Re: FirstLight Hydro Generating Company, Turners Falls Hydroelectric Project (FERC No. 1889) and Northfield Mountain Pumped Storage Project (FERC No. 2485). Response to Stakeholder Requests for Study Modifications and/or New Studies Based on the Study Report and Meeting Summary

Attached: Study Report Comments and Responses

Figure 1: Conditions experienced by eel passing via Cabot Powerhouse

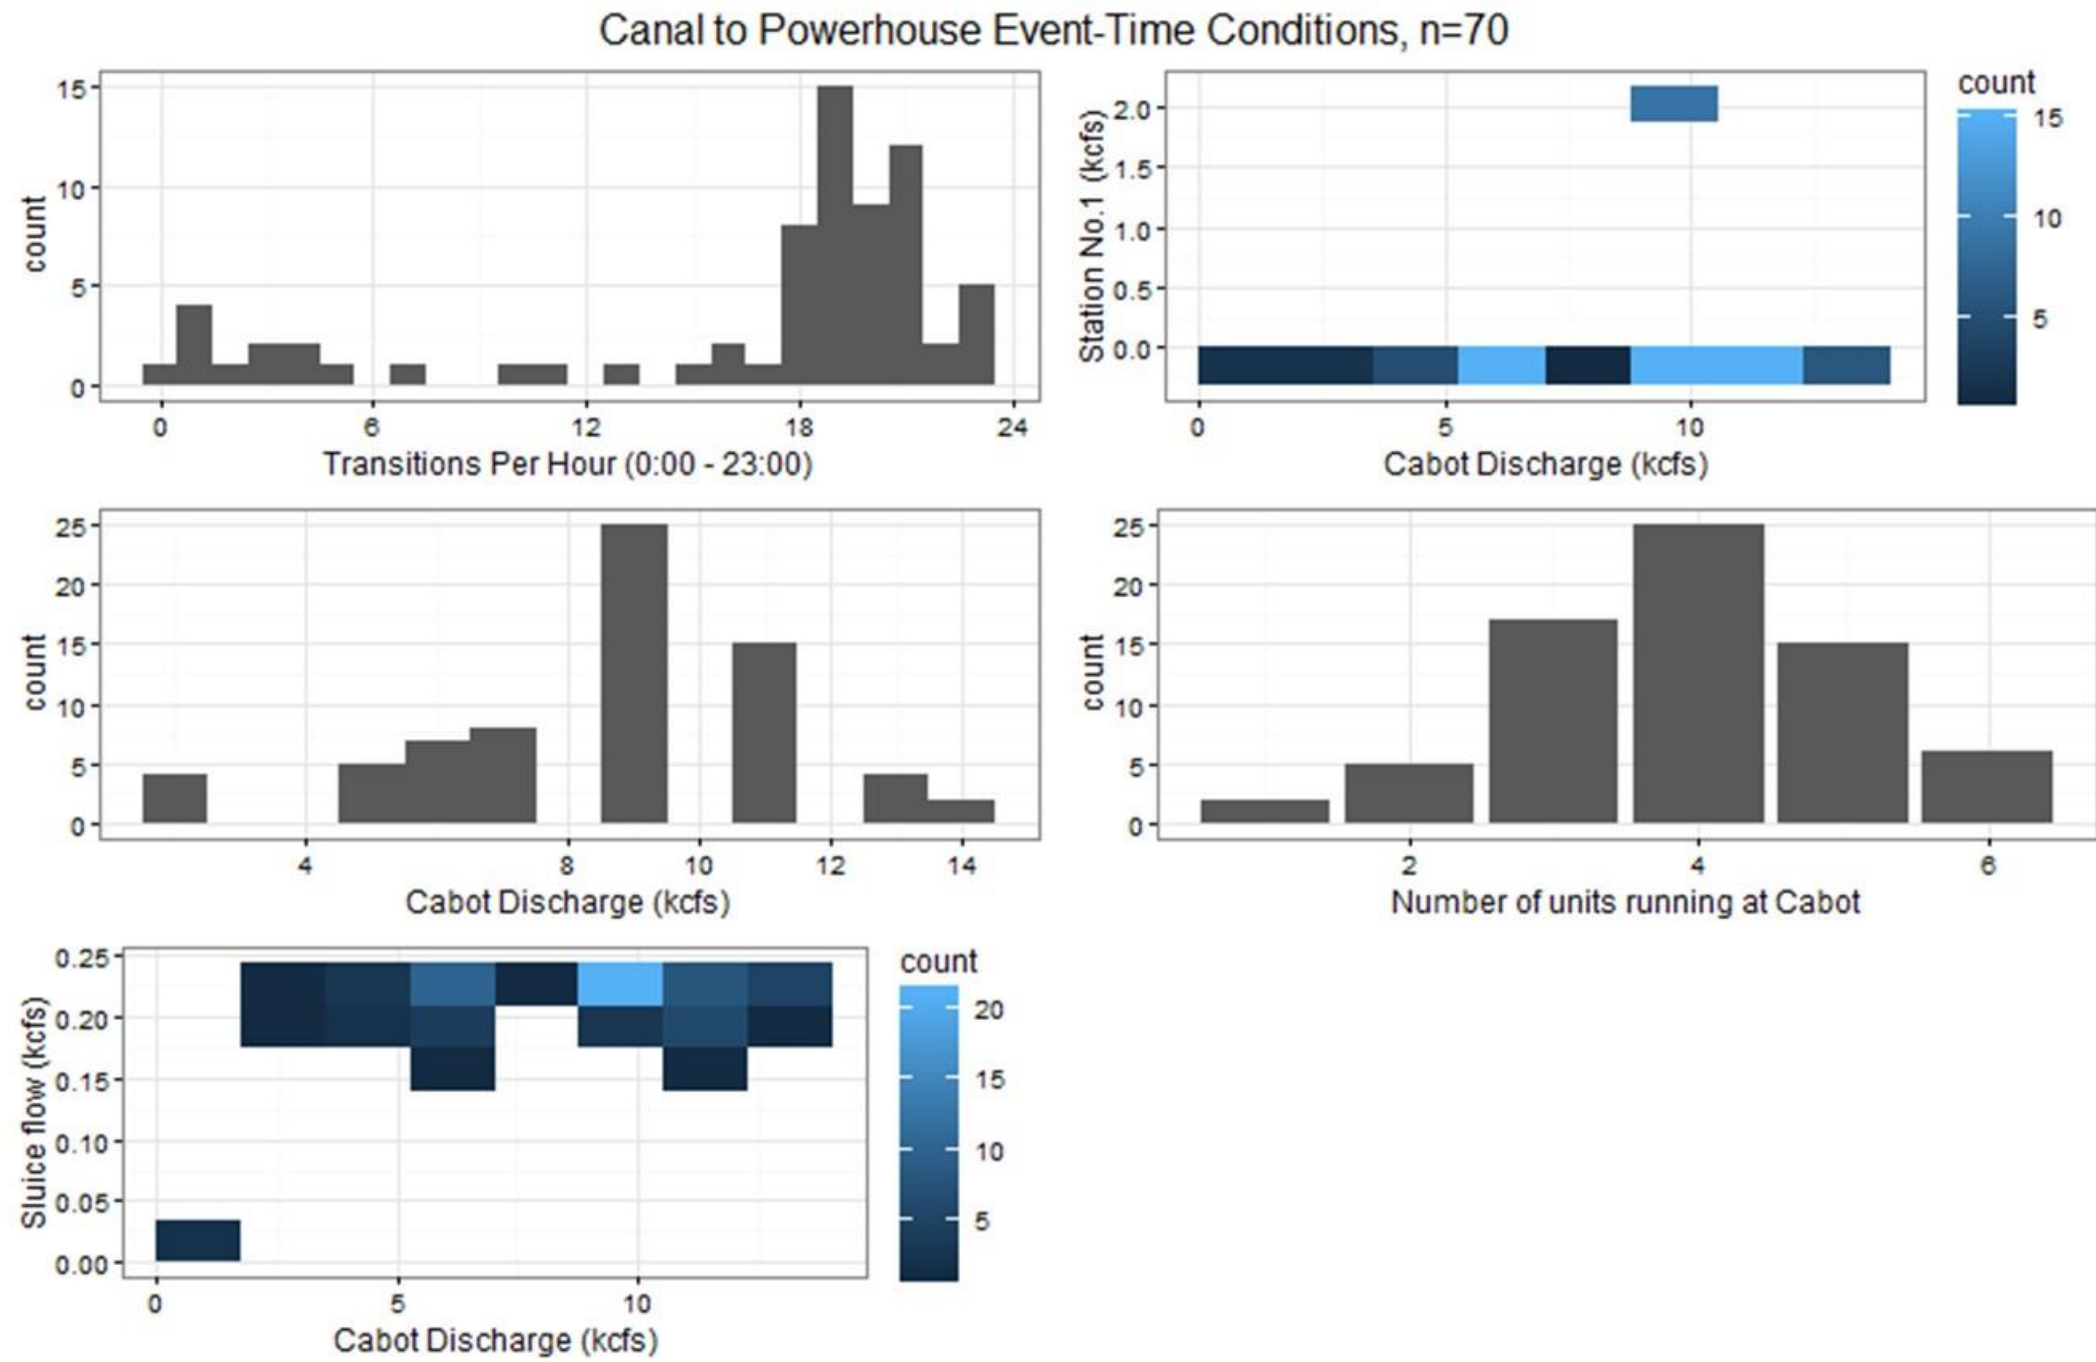
USFWS-5	<p>Assessment of Escapement from the Power Canal</p> <p>Of the 87 fish that entered the canal, 83 percent passed through the Cabot Station turbines, 8 percent used the downstream bypass, 3 percent went through Station No. 1, and the remainder entered an unknown state. CPH model results showed that eels are motivated to pass Cabot Station at night during high discharge events. No CPH analyses could be run for fish choosing the downstream bypass or Station 1 due to the small sample size. Once in the canal, most eels passed through the Cabot Powerhouse quickly (within 6 hours).</p> <p><i>Recommendations:</i></p>	<p>See response to NMFS-5 and 3.3.5 Attachment G</p>

A series of five histograms and plots were made to visualize some of the conditions experiences by eel in the canal that pass via the Cabot Powerhouse ([Figure 1](#)). The upper left plot displays the transitions through the Powerhouse per hour. It is clear that the majority of the eel pass during the nighttime or in the early morning hours. The top right figure is a two dimensional colot plot that displays the operational conditions at Station No.1 and Cabot Station during passage. The lighter blues convey convey the highest counts of eel and can be seen when nothing is happening at Station No.1 and throughout varied operational conditions at Cabot Station. The highest amounts tend to occur when Cabot Station is operating above 5000 cfs. The middle left plot displays the amount of eel passing through the Powerhouse and the associated operations at Cabot. The highest amount of eel (~25) passed through the Powerhouse when Cabot Station was operating between 8000 and 10000 cfs. The middle right plot shows the amount of units running at Cabot Station and the number of eels passing through the Powerhouse. The majority of eels pass through the Powerhouse when 4 units are pumping. The last plot on the lower left is another two dimensional color plot related the operations at Cabot Station and the bypass sluice flow. Eels seem to pass through the Powerhouse when flow is going through the sluiceway right and right around 10000 cfs going through the Powerhouse.

Attachment I to Study 3.3.5.
Figure 1: Number of eel recaptured at each station

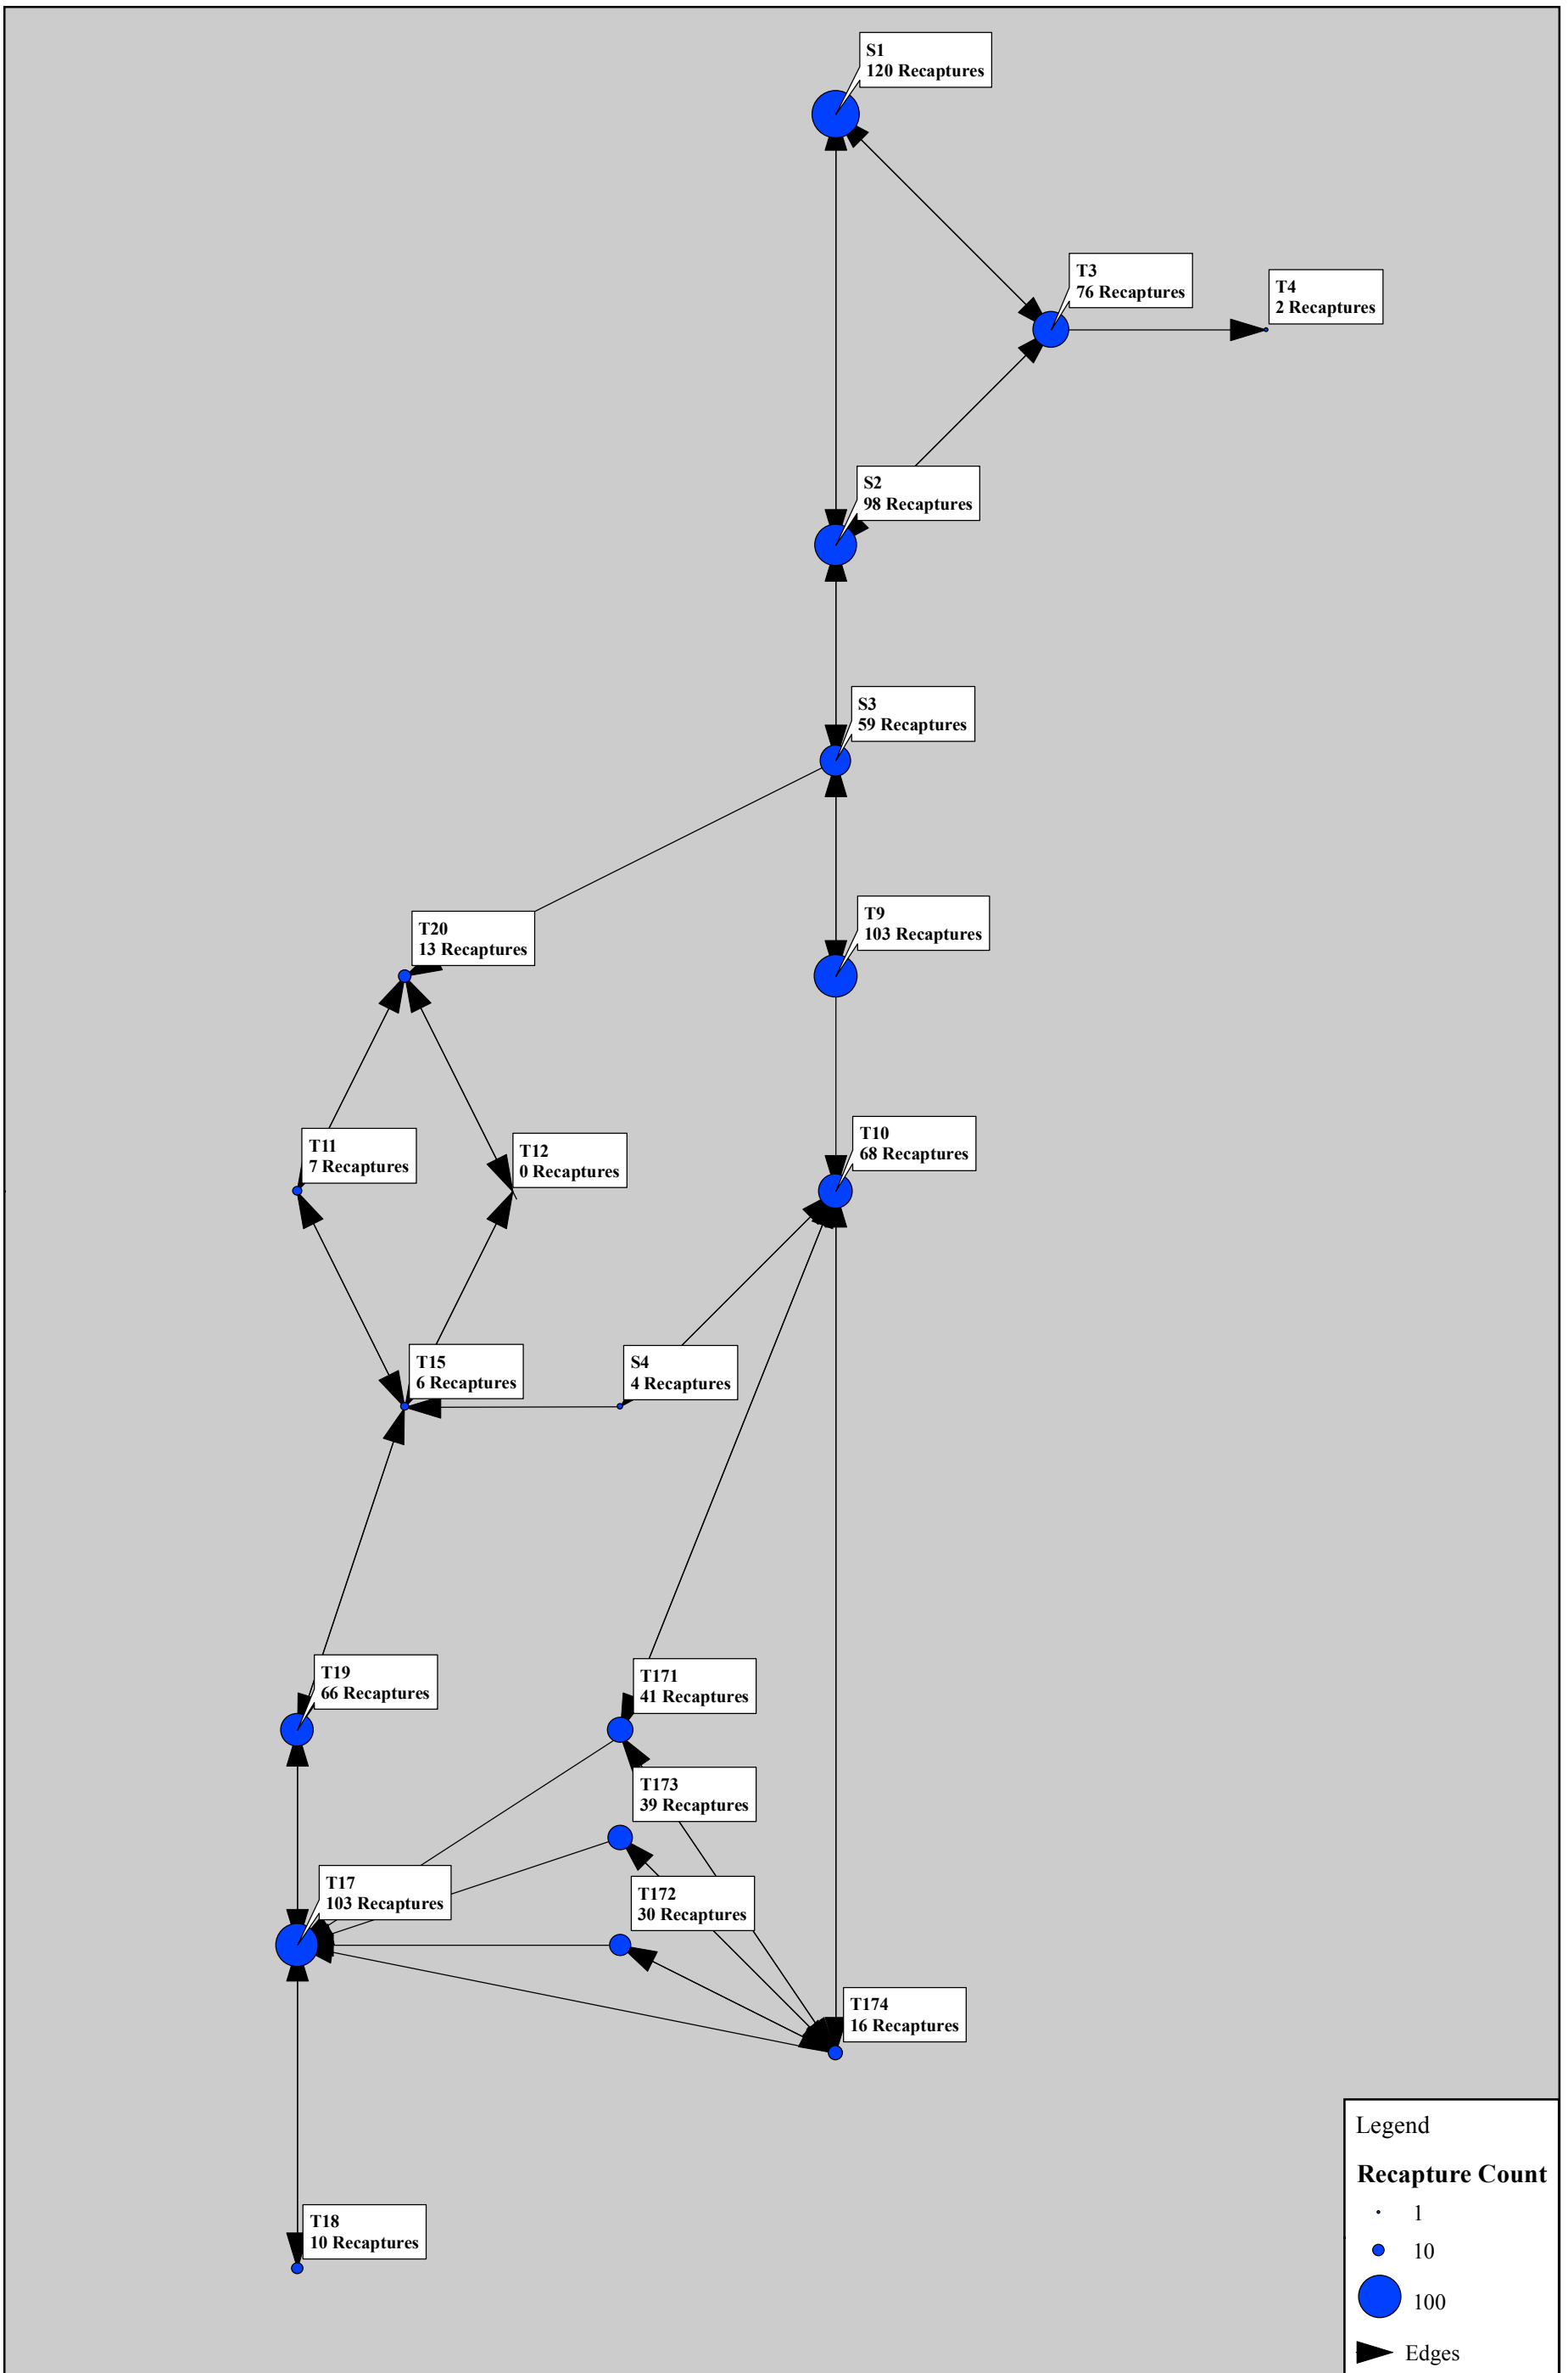
USFWS-2	<p>Probability of Movement through Project</p> <p>One hundred seventy radio-telemetered eels were released or available to monitor through the project area. Test eels took between 2 and 26 days from release to leave the tailrace, with 35 percent passing the tailrace within 2 days after release and 72 percent passing within 6 days of release. Upon reviewing the data, FL determined that it had the ability to use the Cormack-Jolly-Seber (CJS) model to estimate survival at least up to the Cabot tailrace.</p> <p><i>Recommendations:</i></p> <p>FL should define the parameter “Project” in Tables 4.3-2 and 4.3-3. Also, it would be helpful to include a graphic like Figure 3.2.3-7 that has the number of radio-tagged eels passing (i.e., detected at) each receiver. Lastly, we recommend adding an appendix that includes individual 3D plots for each eel’s path history (like Figure 3.2.5-1), or 2D plots with receiver ID on the Y-axis and Date on the X-axis.</p>	<p>In Tables 4.3-2 and 4.3-3, “Project” refers to stations below Turners Falls Dam and above Cabot Tailrace, specifically T10, T11, T12, T13, T14, T15, T20, T171, T172, T173, and T174. Attachment 3-3-5 H includes 2D plots of each fish’s relative location on the river over time, with location on the y-axis and time on the x-axis. Fish ID numbers 149.740 37, 149.740 45, 149.740 47, 149.760 29, 149.760 41, and 149.760 54 each only had single detections so they are not presented in the appendix. Two fish, 149.740 56 and 150.340 104, were confirmed to be entrained during the study. The 2D plots show these two fish making upstream movements at the end of their detection histories – this represents entrainment into the Upper Reservoir, not upstream movement within the CT River.</p> <p>3.3.5 Attachment I includes a graphic showing number of eel recaptured at each station.</p>
